Gatwick Airport Northern Runway Project

Supporting Noise and Vibration Technical Notes to the Statements of Common Ground - Book 10 – Version 1- April 2024 – Document reference 10.13 [REP3-071] Review

Supporting Noise and Vibration Technical Note Review [\[REP 3-071\]](#)

¹ Figure 1 of Basis of Calculation for Engine Test Runs – Dr Thomas Schenk – KSZ Ingenieurburo GmbH (2013)

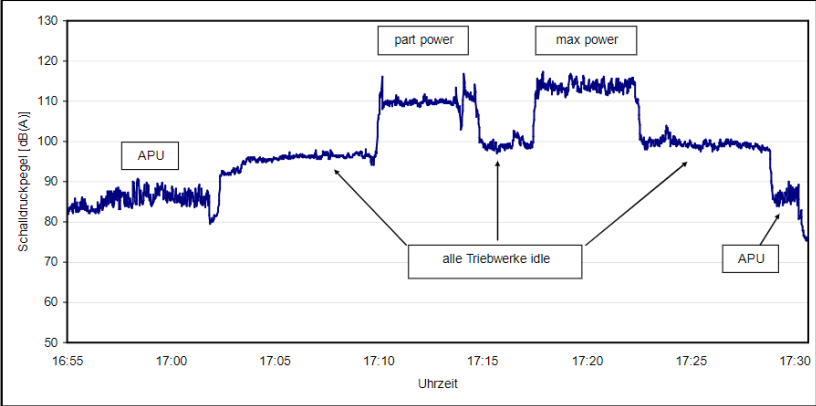
JLA-NVTN-E5	2.6.9	Justification for not identifying significant effects	The Applicant has attempted to provide some indication on how engine testing would contribute to the L _{Aeq,T} metric with some rather outlandish assumptions. Paragraph 2.7.2 [REP1-050] states that peak engine testing noise levels would last for two minutes and events would occur, on average, 0.35 times per day. As such, engine testing noise L _{Aeq,T} noise has been calculated based on event lasting for 0.7 minutes (42 seconds). An example of a typical jet aircraft engine test is provided in the figure below ¹ .

<p>The duration of this typical event is 25-minutes and the figure illustrates that high levels of noise (at a distance of 100m) occur for the duration of the event. It would be helpful if the Applicant could provide a typical engine testing profile that could be used to model ground noise such that ground running events would contribute to LAeq,T ground noise levels. This should be modelled as one event occurring on a reasonable worst-case day and should not be modelled as a partial event for an average day. Engine ground running noise should be included in the assessment of likely significant effects through its contribution to LAeq,T noise levels on a reasonable worst-case day.</p>
JLA-NVTN-E6	3.1.1	The ground noise assessment is robust and cautious	The JLAs dispute this statement and are of the opinion that the ground noise assessment is not fit for purpose. The JLAs urge the Examining Authority to request the Applicant to update their ground noise assessment and address issues identified in [REP1-068] and [REP1-097] .
